Report FL #: 10088 for Greenheck models EHH-601D & ESD-635D (both w/ and w/o VCD-40 Damper)

Report FL #: 10093 for Airolite models SCH601MD & K6746MD (both w/ and w/o VCD-40 Damper)

NOTICE OF ACCEPTANCE (NOA)

APPROVAL DOCUMENT: Drawing No. **EHH-601D**, titled "EHH-601D Louver", sheets 1 through 35 of 35, dated 08/09/2017, prepared by Greenheck Fan Corporation, signed and sealed by Wayne K. Helmila, P.E. on 09/27/2024, bearing the Miami-Dade County Product Control revision stamp with the Notice of Acceptance number and expiration date by the Miami-Dade County Product Control Section.

7
8
HEAD DETAIL
LOUVER HEIGHT ≤ 96 IN.
CONTINUOUS ANGLE MOUNT

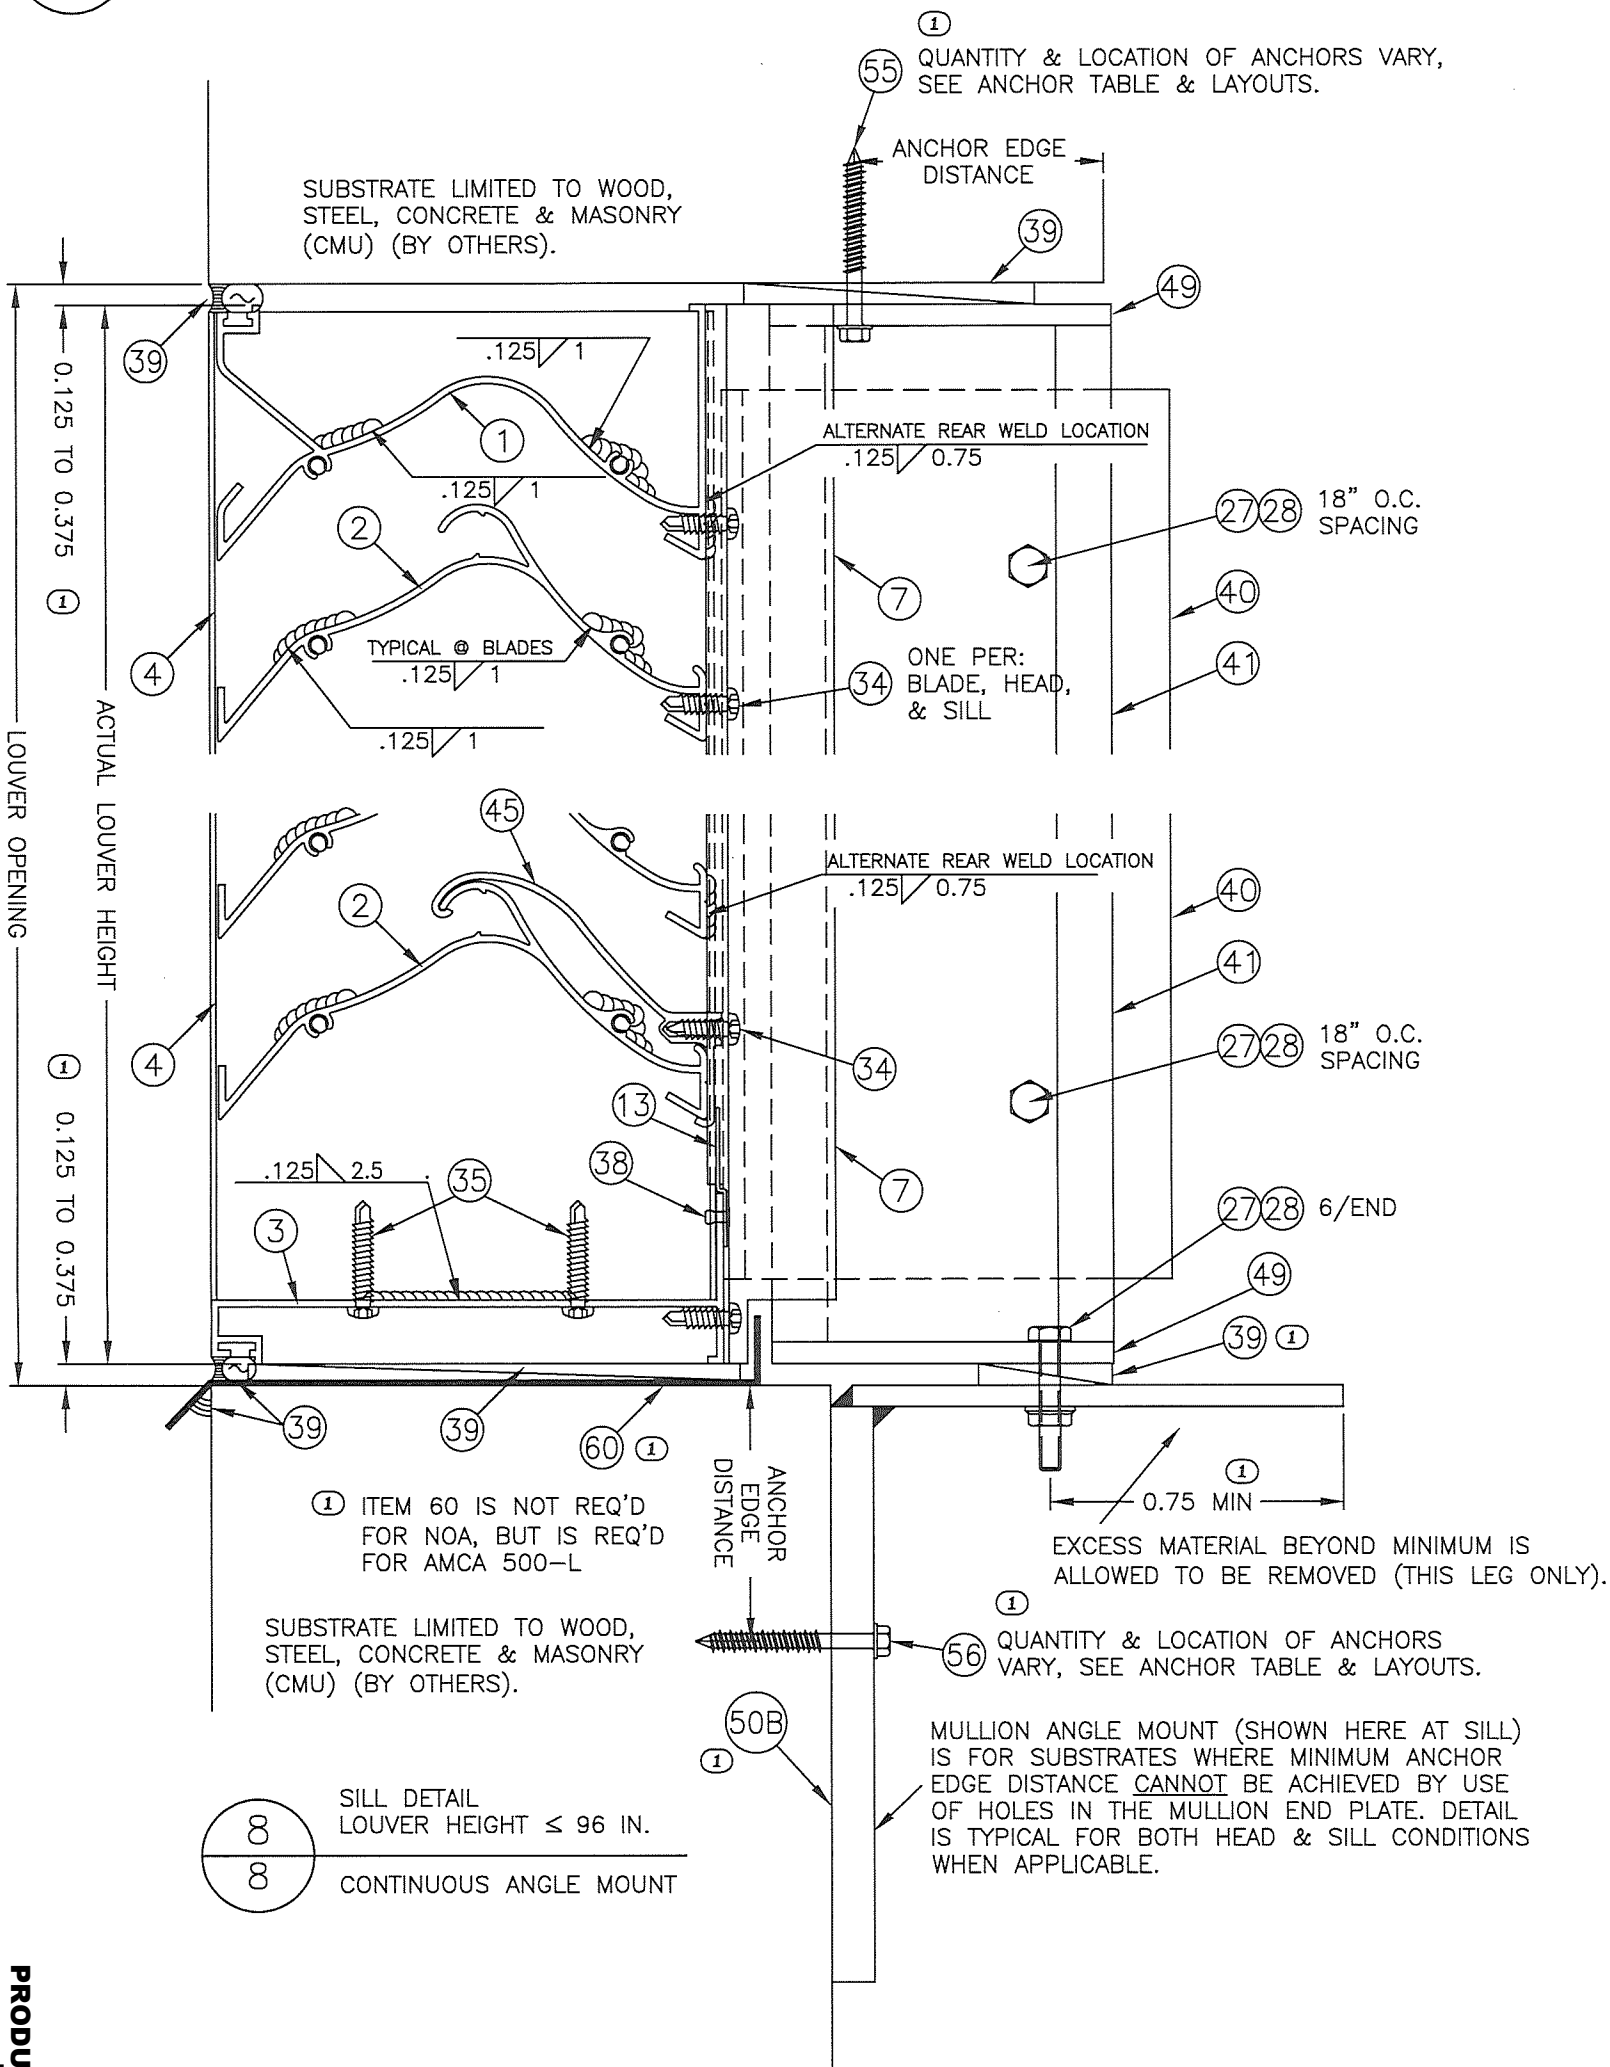
REV 01: 8/1/24, MOVED DETAILS 7 & 8 TO THIS NEW PAGE, ADDED ITEM 39, ADDED MIN OFFSET, UPDATED ANCHOR NOTE X2, UPDATED ITEM 50 CALLOUT & LAYOUT, REMOVED "TYP" FROM EDGE GAP X2, & ADDED ITEM 60 WITH NOTE.

GREENHECK P.O. BOX 410 SCHOFIELD, WISCONSIN 54476-0410	DRAWN BY MES	DATE 8/9/2017
	SCALE	
TITLE EHH-601D LOUVER FLANGE FRAME SLEEVE MOUNT JAMB & SUPPORT DETAILS H≤144"	SHEET NO. 9 OF 35	
	CAD DRAWING NO. EHH-601D

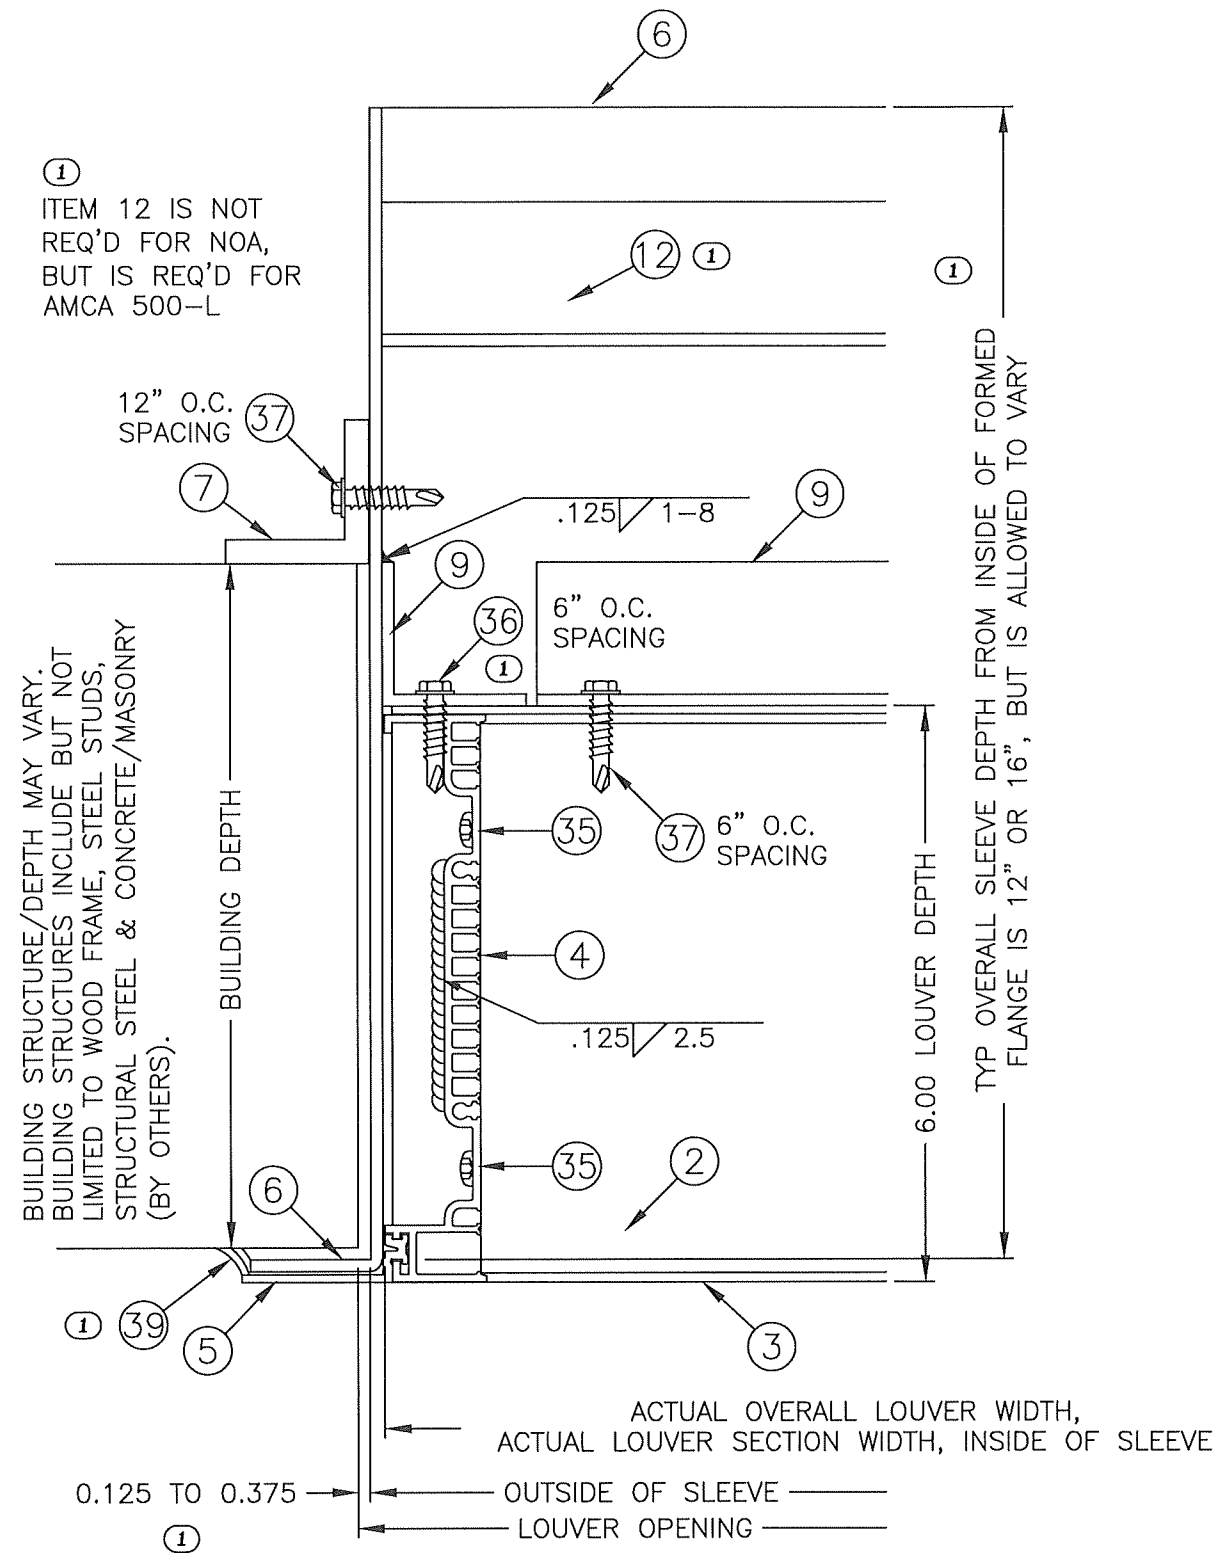
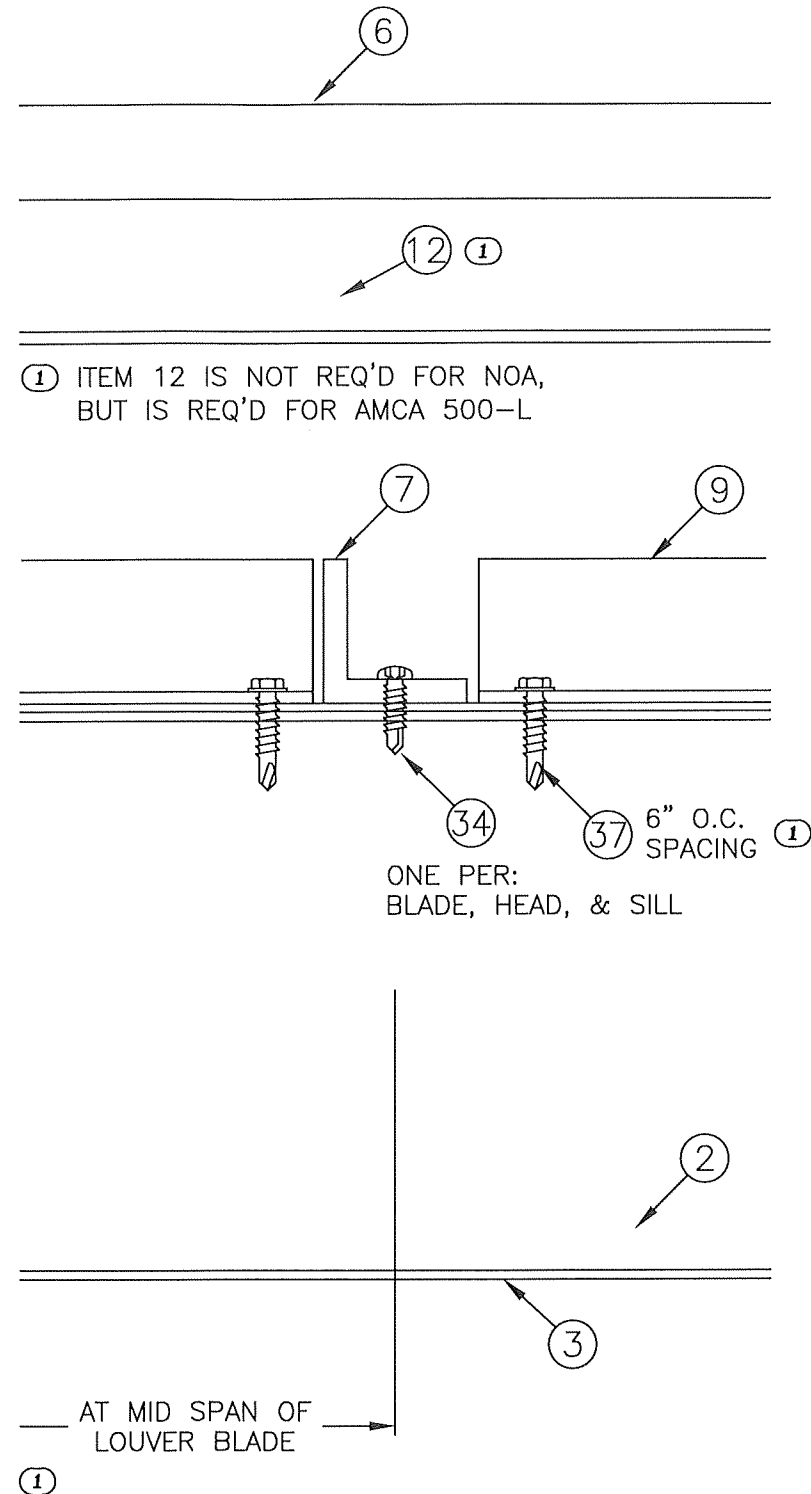
REV 01: 8/1/24, WAS PAGE 8, ADDED SLEEVE & LOUVER DEPTH DIMS, REPLACED ITEM 37 WITH ITEM 36, ADDED ON CENTER, ADDED ITEM 39, ADDED ITEM 12 X2 & ITS NOTE X2, ADDED MID SPAN DIM, & REMOVED "TYP" FROM EDGE GAP.

DRAWN BY MES	DATE 8/9/2017	SCALE	SHEET NO. 10 OF 35	CAD DRAWING NO. EHH-601D
GREENHECK P.O. BOX 410 SCHOFIELD, WISCONSIN 54476-0410 				
TITLE EHH-601D LOUVER CONTINUOUS ANGLE MOUNT JAMB & SUPPORT DETAILS H≤144"

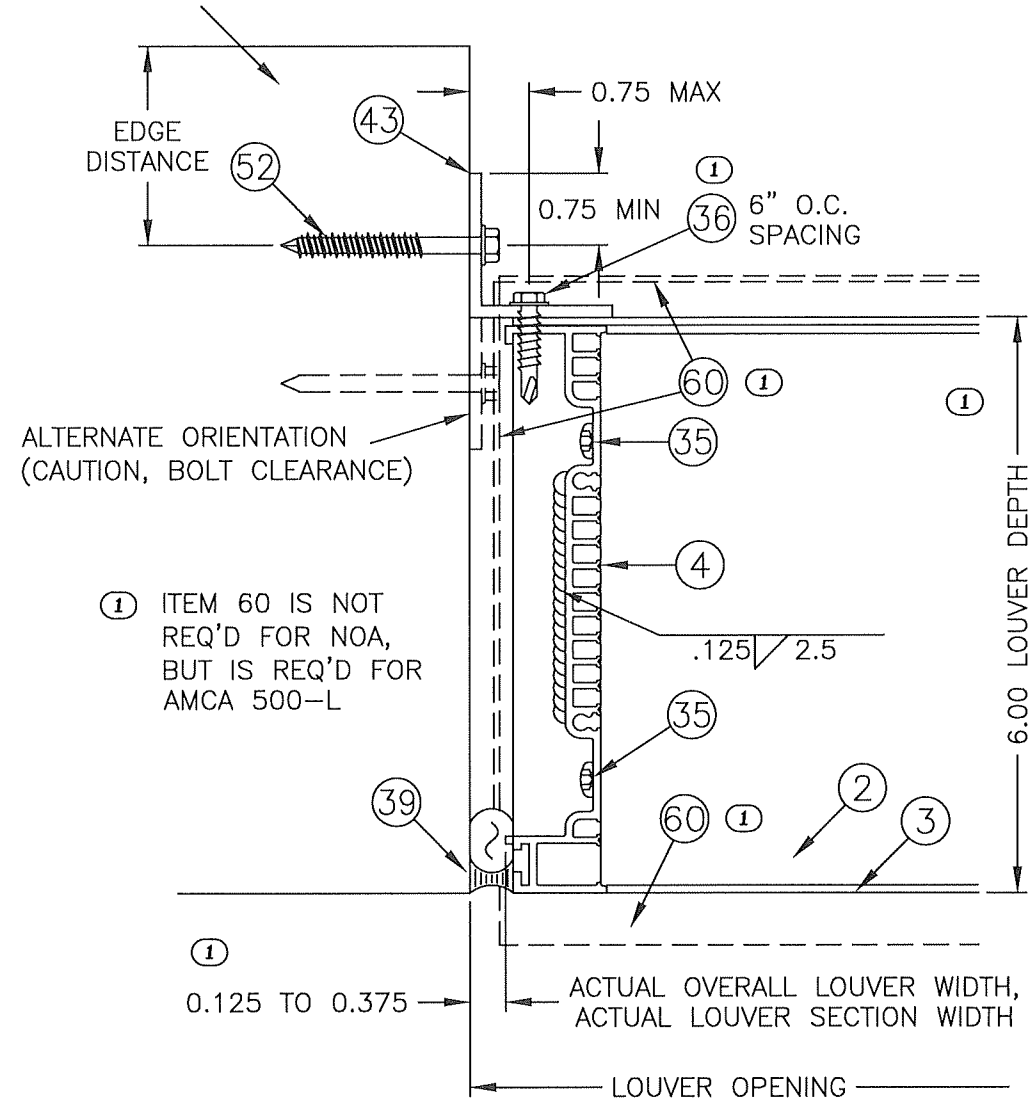
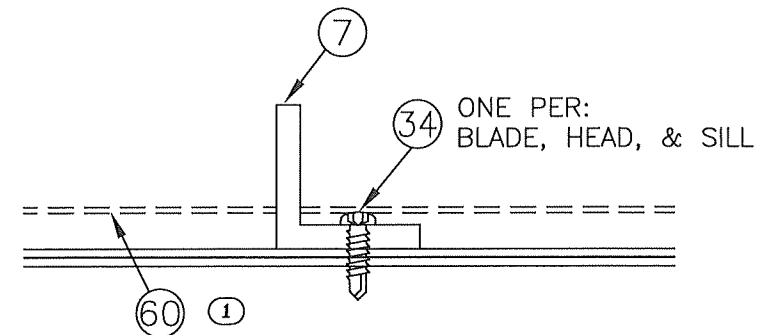
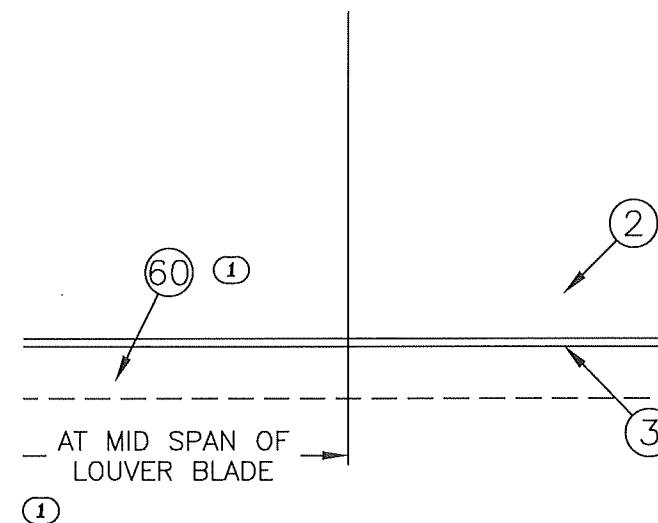
REV 01: 8/1/24, WAS PAGE 9, REPLACED ITEM 37 WITH ITEM 36, ADDED
DEPTH DIM, REMOVED "TYP" FROM EDGE GAP, ADDED ITEM 60 X4 & ITS
NOTE X2, ADDED MID SPAN DIM, & UPDATED DETAIL 12 TITLE TO 144 IN.
